Department of Energy  
Washington, D.C. 20545

Docket No. 50-537  
HQ:S:82:050

RESPONSES TO REQUEST FOR ADDITIONAL INFORMATION

Reference: Letter, P. S. Check to J. R. Longenecker, "CRBRP Request for Additional Information," dated March 16 and 25, 1982

Figure 5.5-2A. Main Steamline Isolation Valve (Superheater Isolation Valve Outlet)

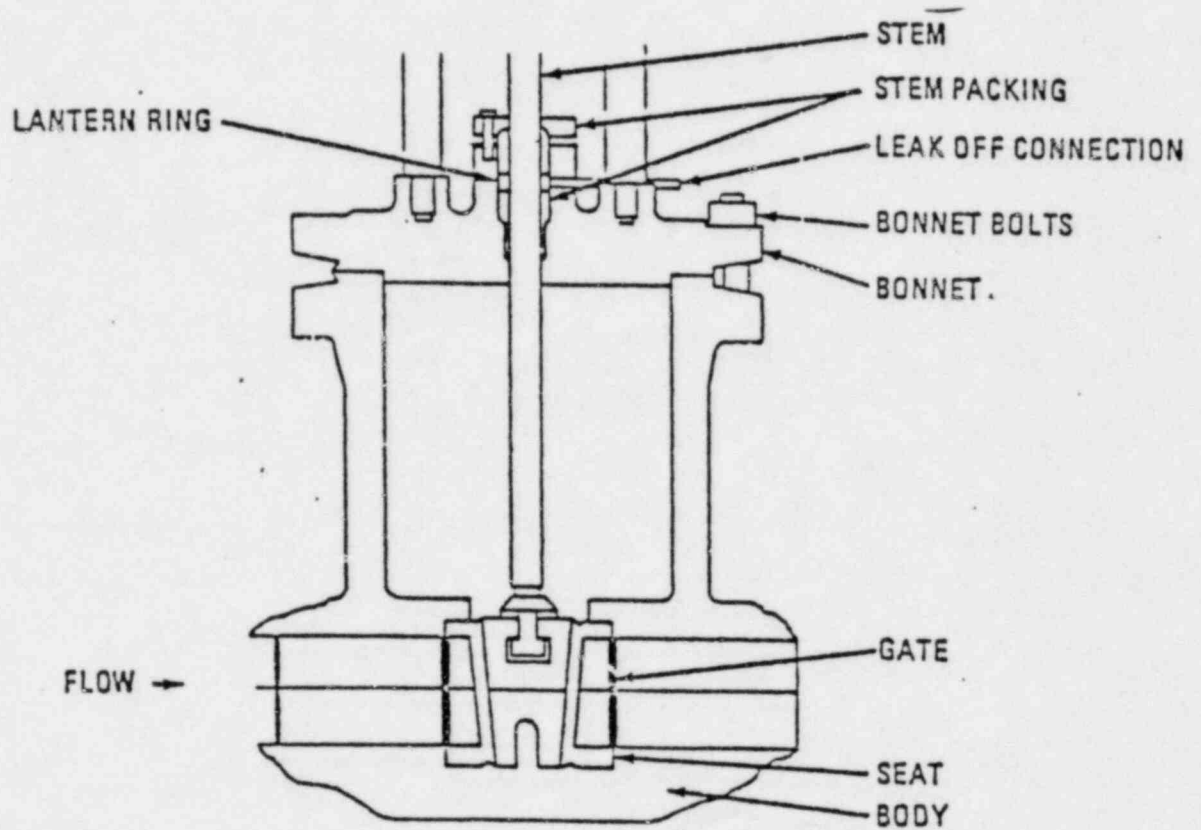
(10.3) As explained in Issue No. 1 of NUREG-0133, credit is taken for all valves downstream of the Main Steam Isolation Valve (MSIV) to limit blowdown of a second steam generator in the event of a steam line break upstream of the MSIV. In order to confirm satisfactory performance following such a steam line break provide a tabulation and descriptive text (as appropriate) in the PSAR of all flow paths that branch off the main steam lines between the MSIV's and the turbine stop valves. For each flow path originating at the main steam lines, provide the following information:

Figure 5.5-2A shows a main steam isolation valve. It is a conventional gate valve to provide a minimum resistance flow path when the valve is wide open. A closed system hydraulic-pneumatic operator, shown in Figure 5.5-2B, is provided for opening and closing the valve during normal operation or during valve exercising. Upon loss of electrical power, the pneumatic and hydraulic solenoids are opened by springs, which causes pneumatic pressure to shuttle the valve operating cylinder. The oil below the valve operating cylinder returns to the reservoir through the pilot check valves, which are piloted open by pressure acting through the hydraulic solenoid valves. The gate valve is accelerated during the initial period of the blowdown and is decelerated at the end of the closing stroke by a hydraulic damper which enables soft seating of the gate while providing fast closing of the valve. A pressure compensated flow regulator ensures uniform closing times over variations in load. Position switches are provided to indicate gate position remotely. The valve is repositioned by energizing the motor and solenoids.

Figure QCS490.24-1  
PLUTO2 Prediction of Peak Fuel  
Motion Reactivity vs. Failure Location

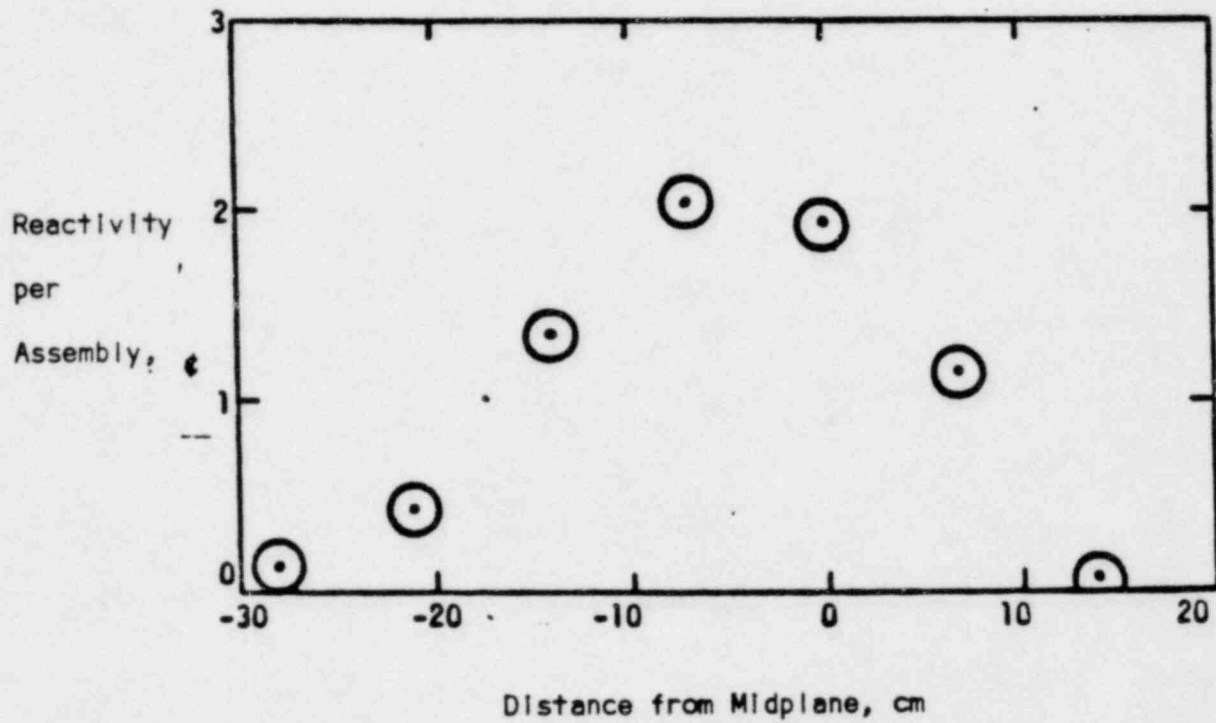
The applicant is requested to comment on: 1) the implications of the early cladding breaches with respect to the adequacy of performance evaluation models in cladding failure criteria being used for the CRBR, and 2) the implications of the midplane site of the fuel expulsion and of the influence the early failure may have had on the location of the site, for beyond-design energetics.

The NRC question speculated that the site of fuel expulsion in the W-2 test may have been influenced by the early cladding breach which was not predicted by current analytical models. This implies that the fuel expulsion site may not be determined accurately within the current models. To address the implication, PLUTO2 calculations have been performed to confirm that the midplane fuel expulsion, which has been analyzed as mentioned above, is the most energetic case. The results of these PLUTO2 calculations are plotted in Figure QCS490.24-1. Examination of Figure QCS490.24-1 shows that the midplane fuel expulsion yields essentially the highest peak positive reactivity feedback from fuel motion. Therefore, it can be said that an early cladding breach may cause at worst fuel expulsion at the midplane, which has been analyzed from the standpoint of the whole core response (Reference QCS490.24-1).
